## Walnut St. Garage Applicant Questions

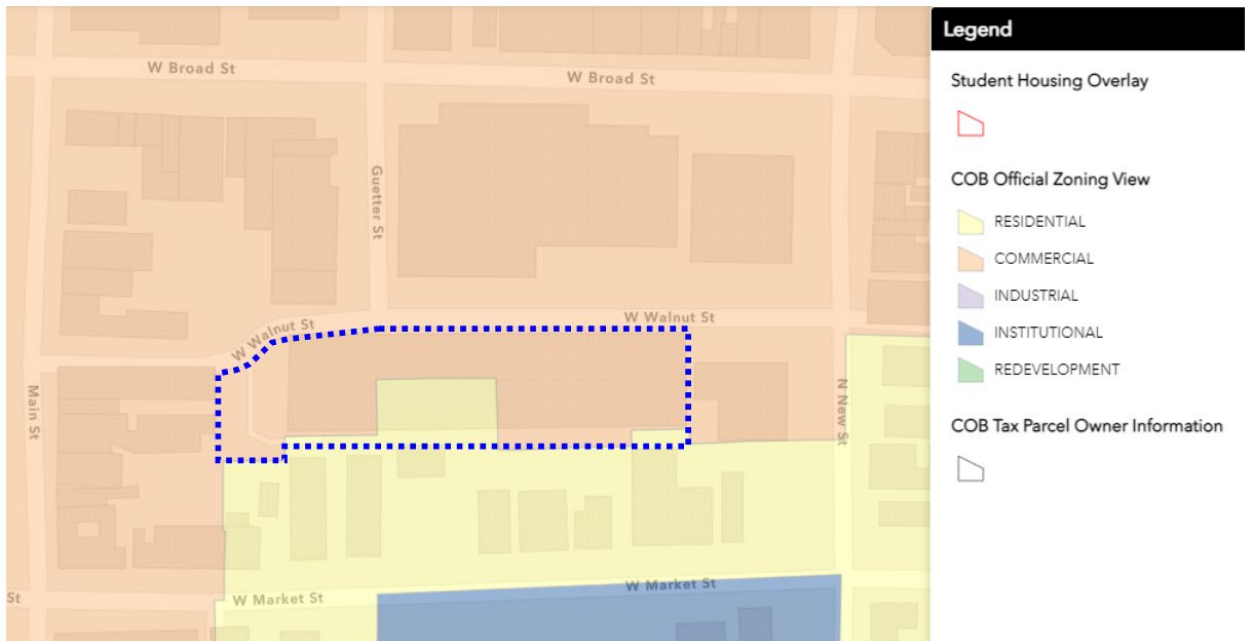
3. According to the City of Bethlehem Zoning Map that is available online (at <https://bethlehem-pa.maps.arcgis.com/apps/webappviewer/index.html?id=58a07399500144a4a6baf44238893c4d>) the project site appears to fall primarily within the Commercial zoning district (see below in orange), but a portion of the site is within the Residential district (yellow). Will the entirety of this site be re-zoned to the same zoning district class?

The Bethlehem Parking Authority will consolidate the existing parcels and subdivide the site to create two new, separate tax parcels, both intended to be zoned as Central Business (CB) District through the appropriate legal processes.
